A12 Chelmsford to A120 Widening Project

Deadline 6 – Comments on further
information received

12 June 2023

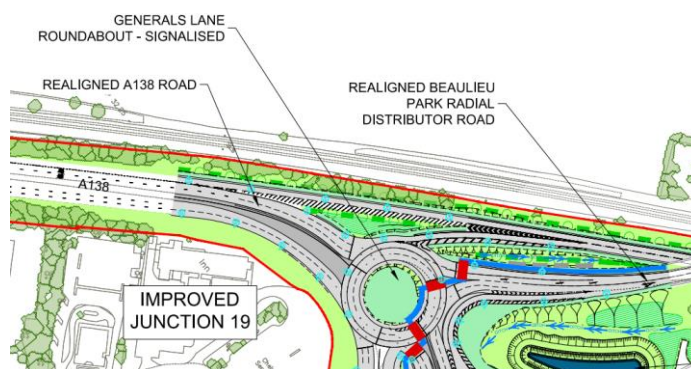
For example, the arrangement of crossings on the northern roundabout of the main junction 19 design (as shown in AS-073 – see image below) requires pedestrians and cyclists to cross over to the central roundabout area and then cross back over the junction to reach the route over the railway line via the re-aligned Beaulieu Park distributor Road. In addition to the issues with the positioning of the stop lines for the crossing over the distributor road itself, there is also very little space on the roundabout between the two sets of signals required to control pedestrian and cycle crossings to and from the centre of the northern roundabout; vehicles stopped here will not only block the movement from the northern to the southern roundabouts, but the Council estimate that once more than 4 or 5 vehicles are queuing, this would extend across the second crossing point and potentially further around the north side of the roundabout, which could result in further delays and extension of queues on other arms of the roundabout. As mentioned above, the Council need to see from the modelling whether these queues do create disruption and to check that this does not affect wider movements around the junction – this is relevant to the Council because if wait times are made too long for pedestrians and cyclists in order to keep traffic moving, this risks people trying to cross inappropriately. It is notable that the southern roundabout at junction 19 takes a different design approach and moves the whole cycle crossing away from the roundabout entry to the southbound on-slip, with a separate pedestrian crossing on the western side of the junction which is able to take up less space as it does not need to also accommodate cyclists.

To progress this matter, the Council would like to be provided with the VISSIM Models for the junctions so we can look at each area of concern and make a judgement as to what specific impacts the current design will have in relation to the issues identified. If the Applicant is unwilling to provide the requested junction models, the Council requests the following information:
